Our Ref: 081801-CUR-XX-XX-T-GE-00003-P01

Kirklees Cultural Heart – Ground Gas Risk Review

Figure 5 - Ternary plot showing gas monitoring data from the site (top). Ternary plot with zones indicating the potential gas sources (NHBC, NF94) (bottom)

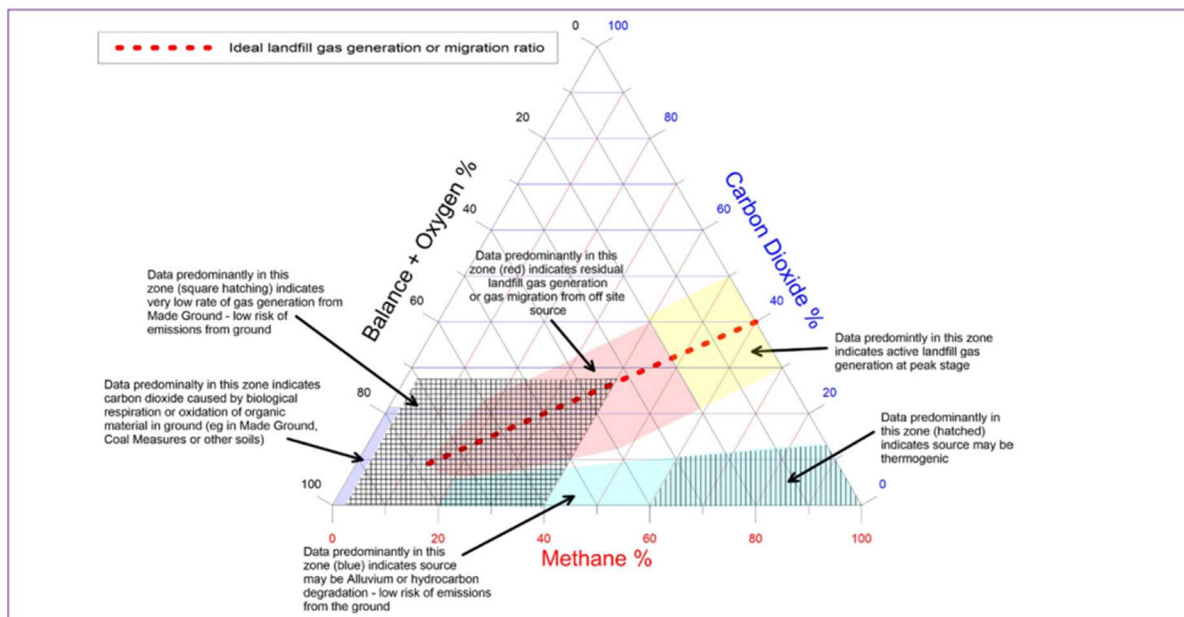
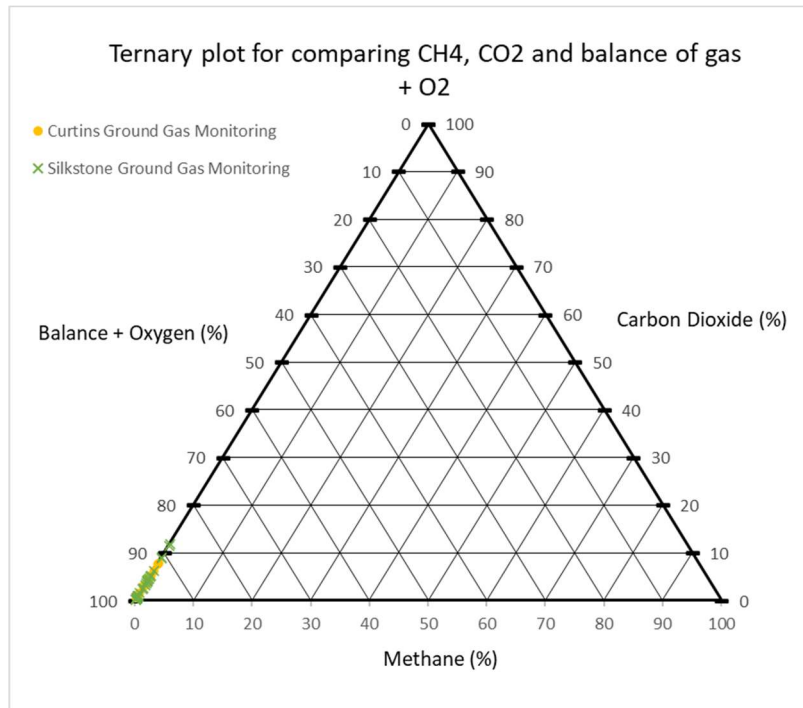
Clause 6.4 of BS8485 (6) states that an assessor should consider increasing (in full cognisance of the conceptual site model) CS1 to CS2 where methane is recorded >1% v/v or where carbon dioxide is recorded >5%v/v. Elevated carbon dioxide (6.2%) was recorded in boreholes BH07 and, as such, further consideration is warranted in this assessment.

Figure 5 indicates that carbon dioxide is likely caused by biological respiration or oxidation of organic material in the made ground, as the site data would lie within the purple shaded area of the NHBC NF94 ternary plot. The NHBC NF94 guidance states that there may be no need to increase a sites classification from CS1 to CS2 if there are concentrations that occur in the purple, light blue or hatched areas and occur only occasionally. Based upon this, it is not considered appropriate to upgrade the CS1 classification to CS2 based on the maximum carbon dioxide concentration.

In reconsidering the conceptual site model, significance of the potential gas sources and gas monitoring data, Curtins considers that the gas risk classification for the site should be CS1 rather than the overly conservative CS2 that derived by Arup (2023) (1). Consequently, no gas protection measures should be incorporated within the development.
